Access Compliance Report Public Rights-of-Way (Curb Ramps)

Main Street: KOOTENAY_DR Cross Street: CRANBROOK_DR Location: NE

ADA ID: RPAT211001101411 Ramp Type: Type 1 - Perpendicular Diagonal Initial Pass/Fail: Pass Overall Compliance: No Severity Score: 20

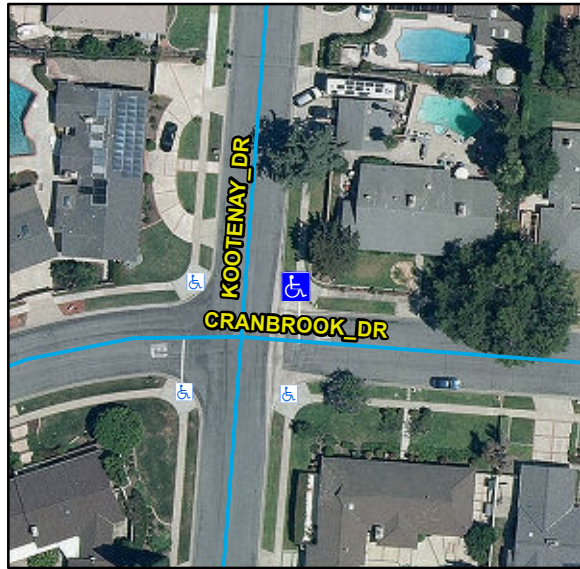
Compliance	Description	Data	Compliance	Description	Data
N/A	Ramp Length (in)	131	N/A	Flare Type LT	
Yes	Ramp Width (in)	56			Sloped
Yes	Ramp Run Slope (%)	6.8	N/A	Flare Slope LT (%)	4.7
Yes	Ramp Cross Slope (%)	0.4	N/A	Flare Traversable LT	No
N/A	Landing Present	No	N/A	Flare Type RT	
N/A	Landing Length (in)	N/A			Sloped
No	Landing Width (in)	N/A	N/A	Flare Slope RT (%)	4.9
No	Landing Run Slope (%)	N/A	N/A	Flare Traversable RT	No
No	Landing Cross Slope (%)	N/A	No	DWS Provided	No
N/A	Landing Movement Obstructed?	No	N/A	DWS Contrast	N/A
	Landing Movement Type	N/A	N/A	DWS Length (in)	N/A
N/A	Landing Shared	N/A	N/A	DWS Full Width	N/A
N/A	Clear Space	Yes	N/A	DWS Offset Left (in)	N/A
N/A	Clear Space To Crosswalk (in)	48	N/A	DWS Offset Right (in)	N/A
N/A	Marked Crosswalk 1	No	N/A	Marked Crosswalk 2	No
	Crossing 1 Direction	W		Crossing 2 Direction	S
	Marked Crosswalk 1 Width (in)	N/A		Marked Crosswalk 2 Width (in)	N/A

N/A	Ramp Inside Crosswalk 1	N/A	Yes	Ramp Inside Crosswalk 2	N/A
	Crossing 1 Slope (%)	5.2		Crossing 2 Slope (%)	0.7
	Crossing 1 Cross Slope (%)	0.3		Crossing 2 Cross Slope (%)	1.6
Yes	Gutter Ponding	No	No	Curb Slope	9.4
Yes	Gutter Lip Height (in)	0		Road Run Slope (%)	0.1
Yes	Gutter Run Slope (%)	4.9		Road Cross Slope (%)	4.3
Yes	Gutter Cross Slope (%)	0.6			
Yes	Overall Surface Condition: Acceptable		No	Perp Joint Present	No
	Cross Gutter Present?	Yes		Spandrel Present?	Yes
	Replace Cross Gutter?	No		Replace Spandrel?	No

Remove & Replace Curb Ramp With Two New Directional Ramps or Equivalent.
